Errata to the MPC8245 Integrated Processor User's Manual, Rev. 2

This errata document describes corrections to the *MPC8245 Integrated Processor User's Manual*, Rev. 2. For convenience, errata items refer to the section and page numbers in the user's manual. Items in bold are new since the last revision of this document.

Figure 10-8. Example I²C Interrupt Service Routine

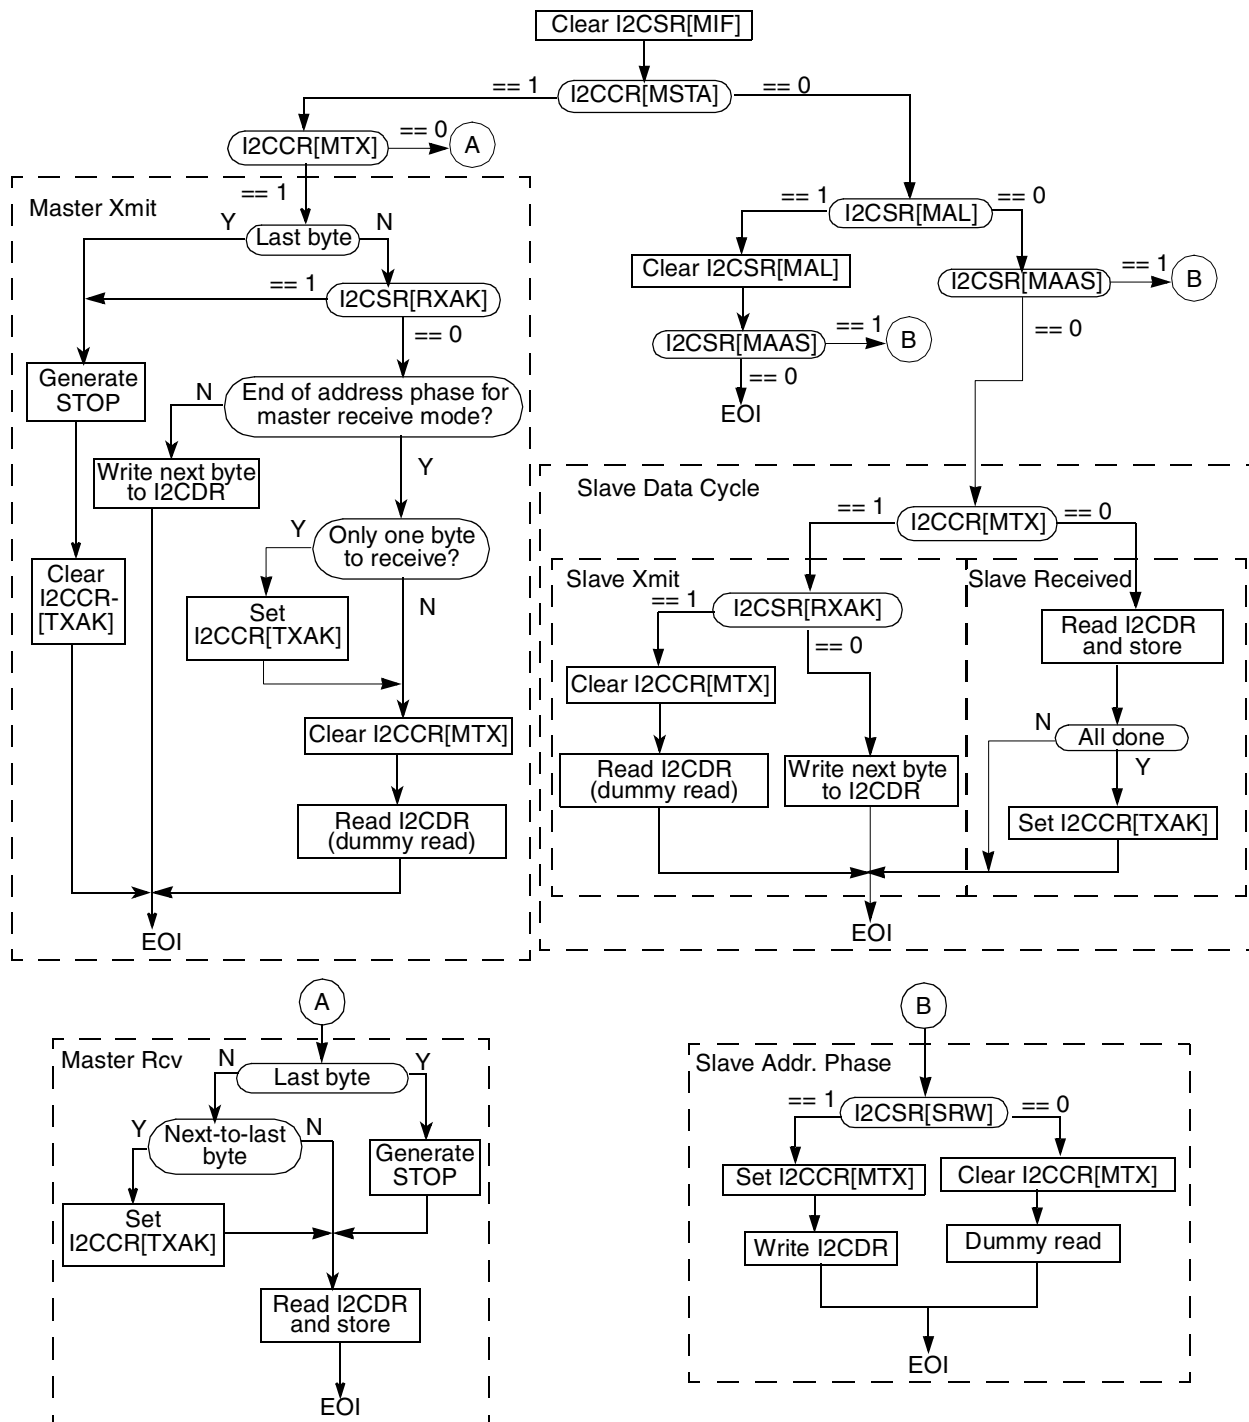
In Figure 10-8, “Example I²C Interrupt Service Routine Flowchart,” replace the two occurrences of I2CCR[MAL] with I2CSR[MAL]. The figure should look as follows:

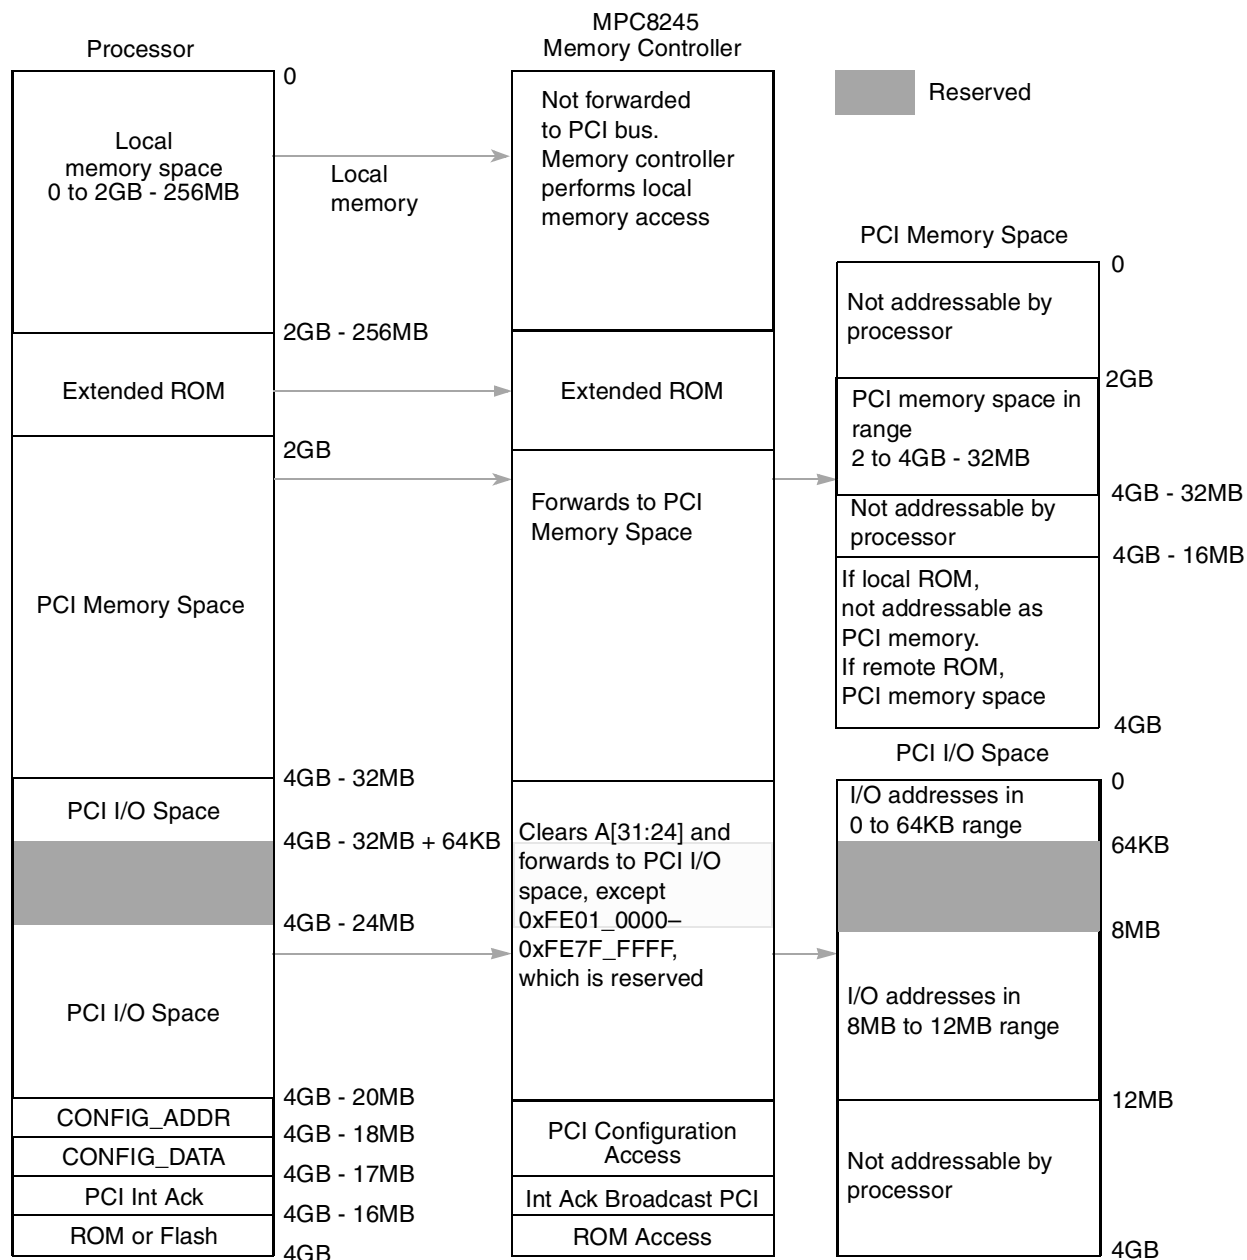
In Figure 3-1, the memory controller range between 2GB and 4GB – 32MB should state “Forwards to PCI memory space,” as follows:

**Figure 3-3. PCI I/O Master Address Map B**

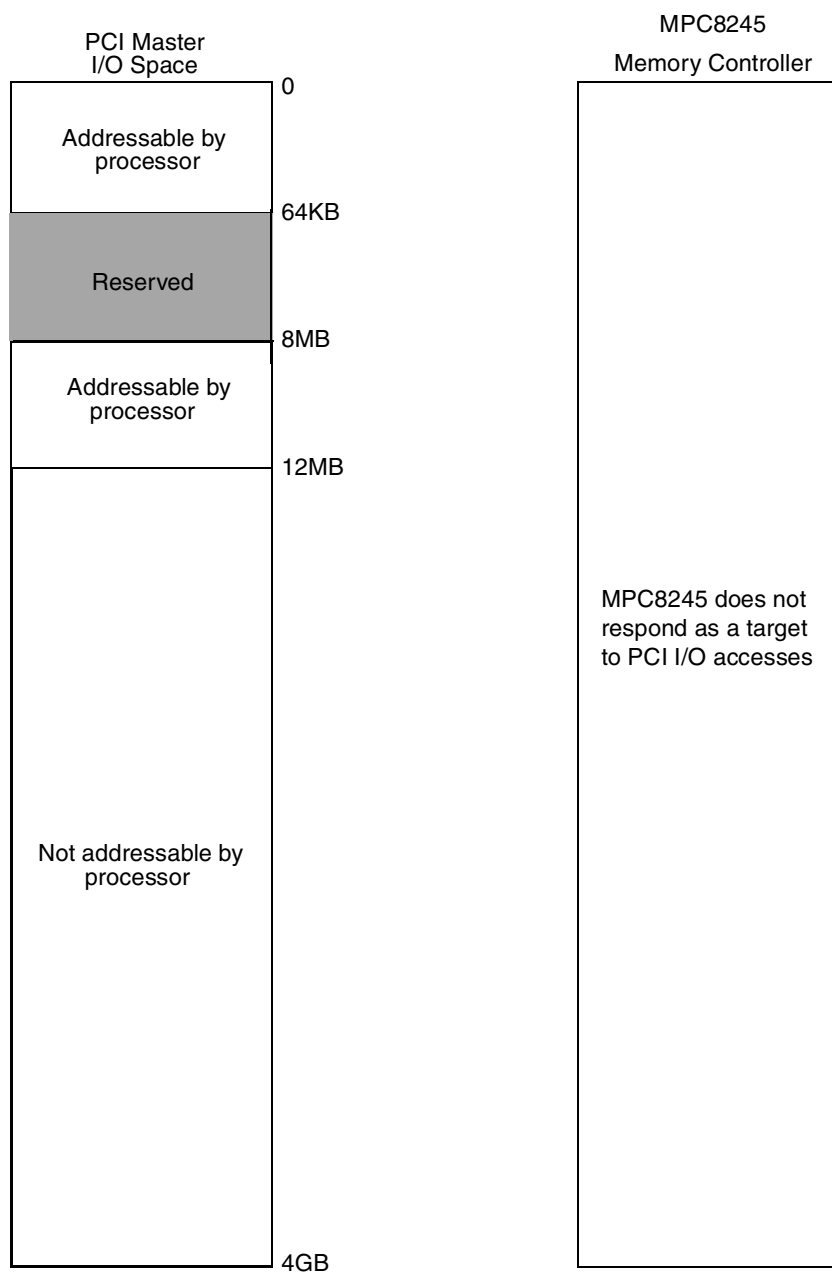
Replace Figure 3-3 with the following:

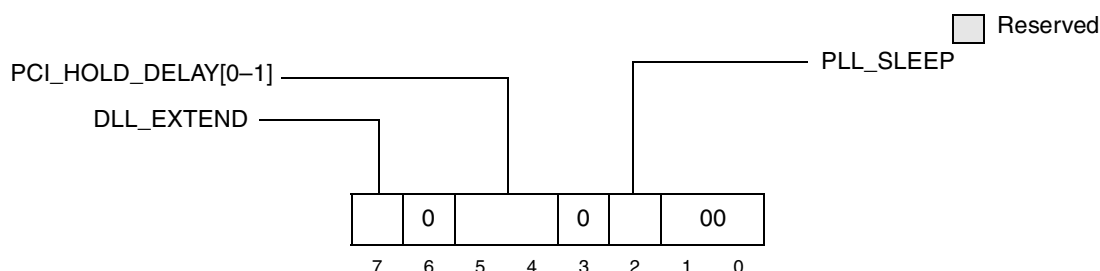
In figure 4-9, PCI_HOLD_DELAY[0-1] should include bits 5-4 as follows:

Figure 4-12. Extended Memory Starting Address Register 1—0x88.

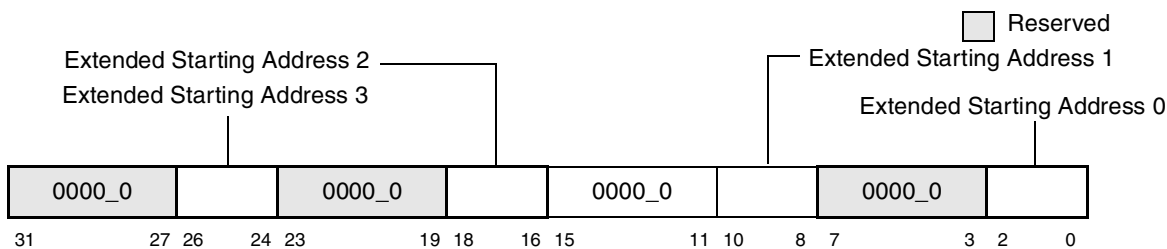
The correct figures for the extended memory starting address registers are as follows:

Figure 4-16. Extended Memory Ending Address Register 1—0x98

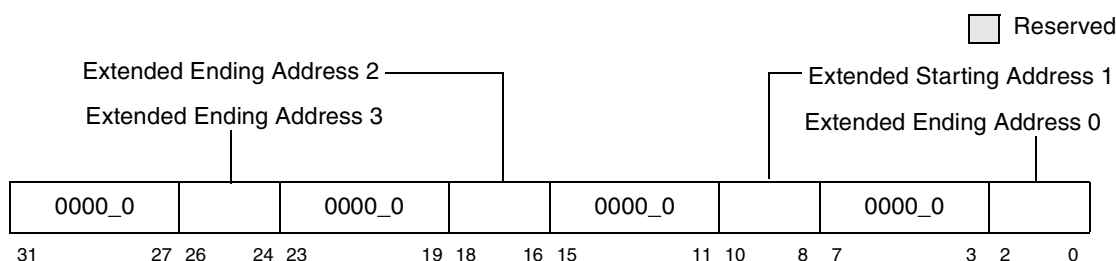
The correct figures for the extended memory ending address registers are as follows:

Figure 4-20. Processor Interface Configuration Register 1 (PIRC1)—0xA8

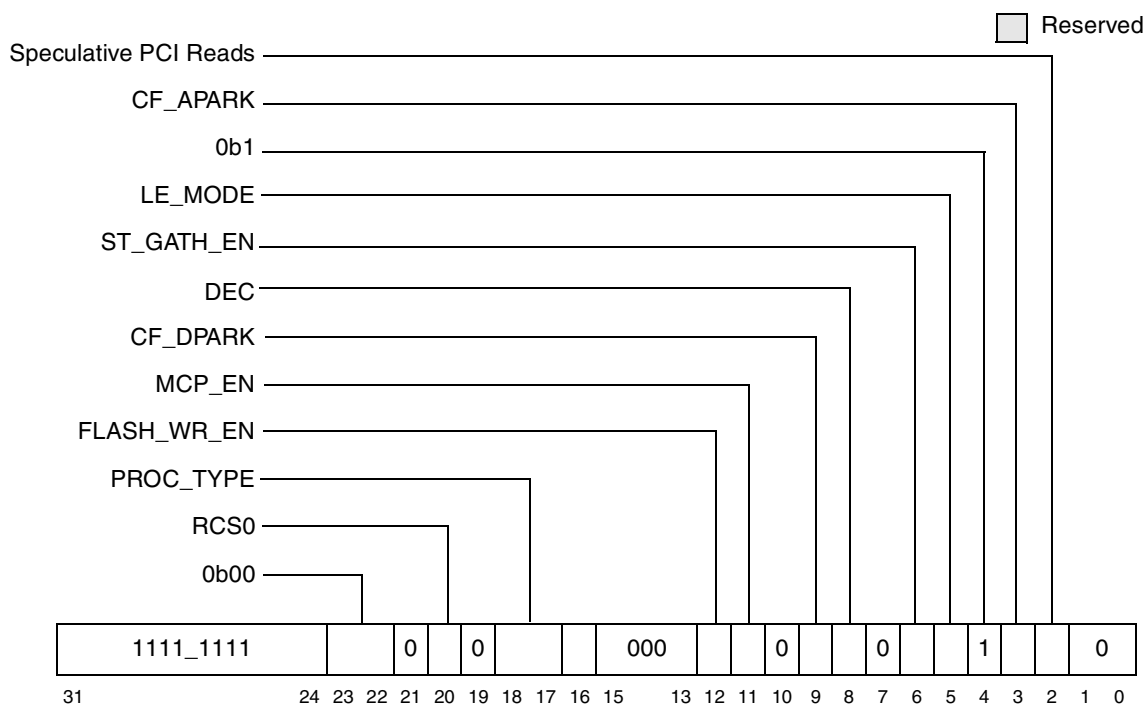
Figure 4-20 should include DEC, bit 8, as follows:

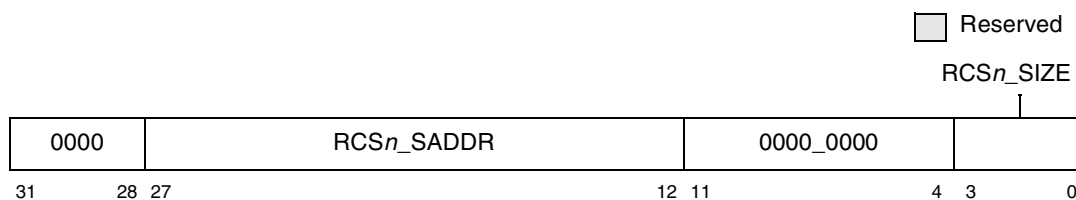
- 4.10, 4-51 In Figure 4-32, the RCS_n_SADDR field is 16 bits long, as follows:

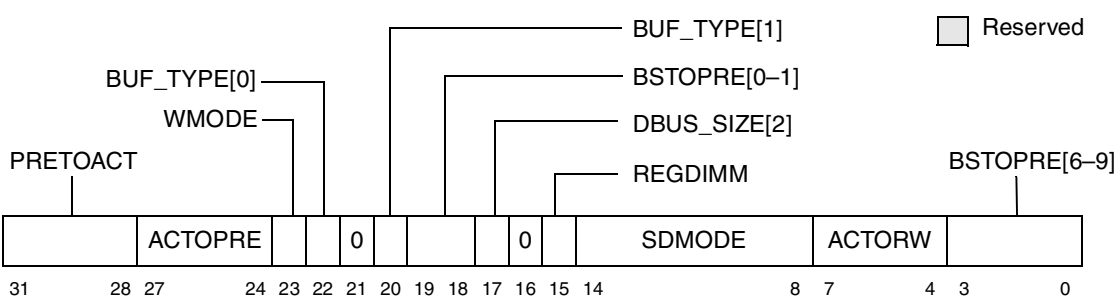
4.13, 4-59 MCCR2[DBUS_SIZE[2]], bit 17, should be included in Figure 4-38 as follows:
